Chapter 4. Changes

This chapter describes change from Code Generator for RL78 (CS+ for CA,CX) V2.08.00 to V2.09.00

4.1.5 Control correction of a competition pin

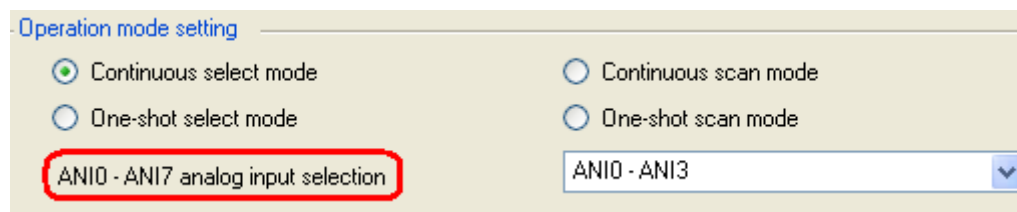
Control of the competition pin when simple-I2C of 24 and 25 pin device of RL78/G13 is set up was corrected.

Before : P17/SDA11
P30/SCL11

After : P50/SDA11
P30/SCL11

4.1.15 Additional function generation file mode

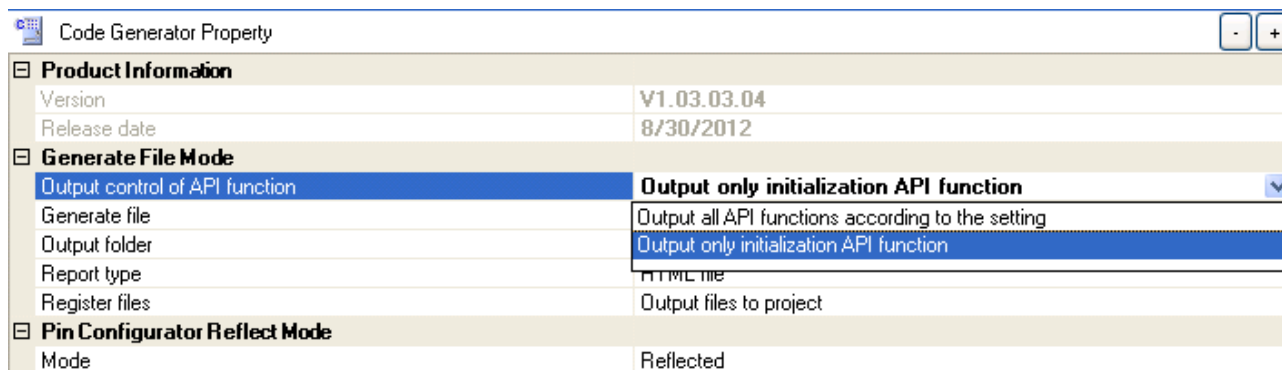
"Output control of API function" has been added to the Code Generator Property for RL78, 78K0R, and 78K0.

"Output all API functions according to the setting": Outputs necessary API functions according to the GUI settings (conventional output method).

"Output only initialization API function": Outputs only initialization functions (Create functions) regardless of the GUI settings.

4.1.18 Changes of input pulse interval measurement of TAU

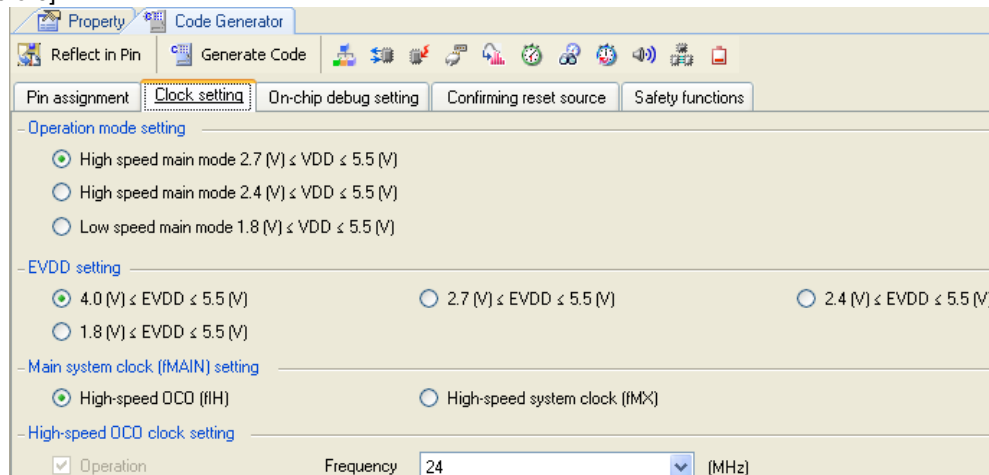
It corrected that the right measured value was not able to be acquired for the input pulse interval measurement function of TAU, and a high / low width measurement function by interruption function `r_taux_channelx_interrupt()` at the time of use.

4.1.19 Changes the notation of a power supply

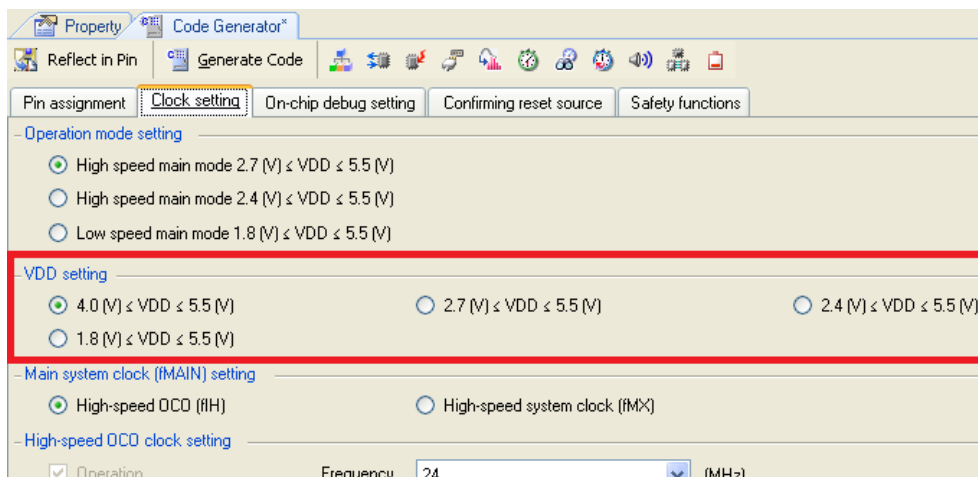
Although there was not EVDD in RL78/G12 device, it corrected that the notation remained on GUI.
